達威電子股份有限公司
Quanta Microsystems, Inc.

Declaration of Authorization

Our product: ZM101

The Grant No is T5U-ZM101

Fig.1 the schematic after change

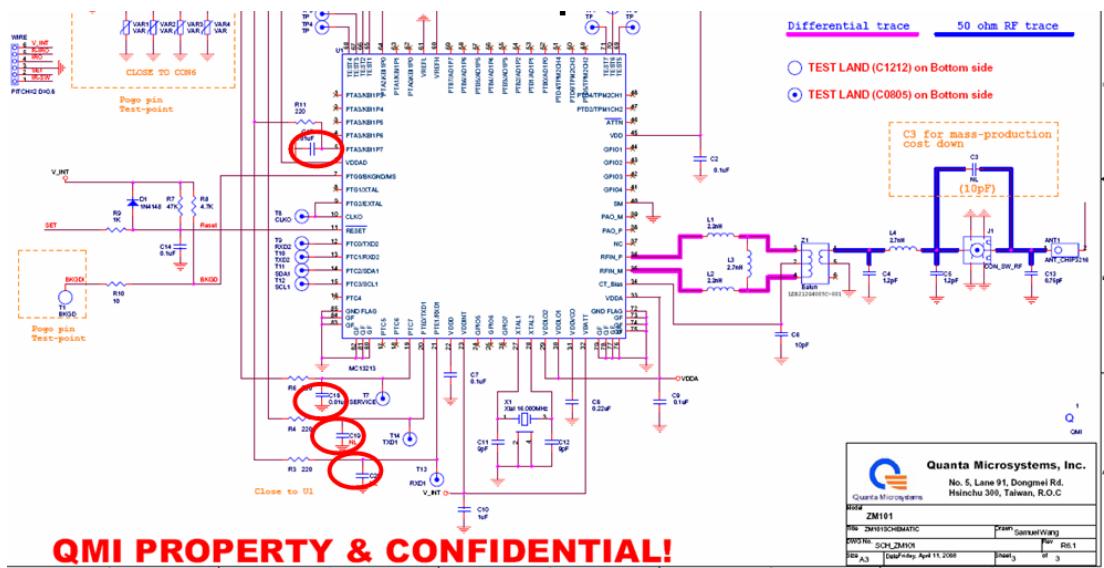
Now, we need to change: The difference of ZM101 and ZM101(REV) is the PCB layout that add some component at uController. We did not change any trace or layout in RF port. Please see the Fig.1 and Fig.2.

ZM101-11: ANT Connector (J1) removed, and add 10pF at C3.

ZM101-21: ANT Connector (J1) removed, and add 10pF at C3. Remove 6Pin Connector means CON6 and Varistors means VAR1~4.

ZM101-31: ANT Connector(J1) removed, and add 10pF at C3. F/W is same as -21 version.

Fig.2 the layout diagram before and after change

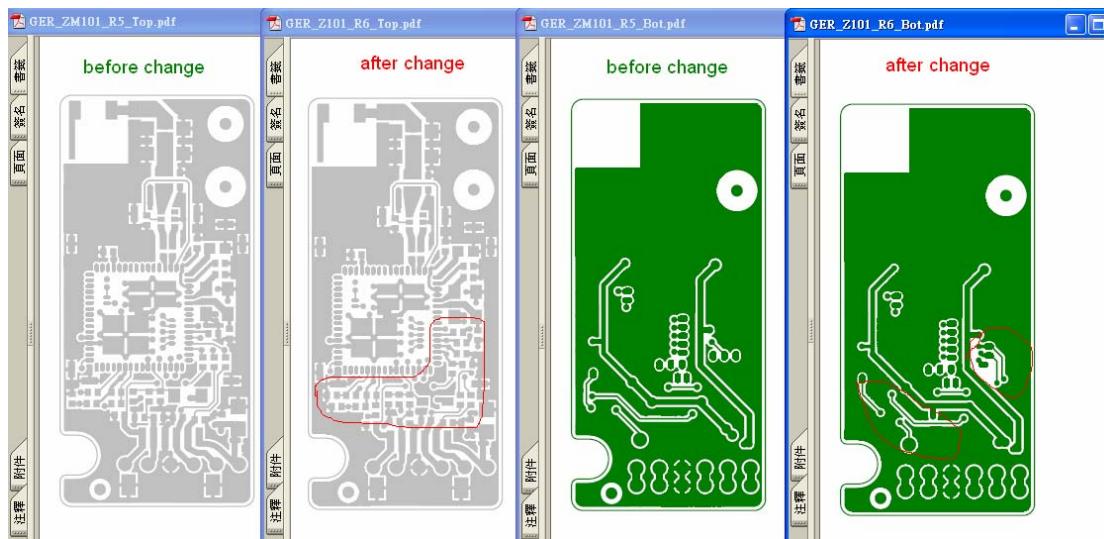
There are no any changes in the radio part and only limited changes in the electric part for the above changing
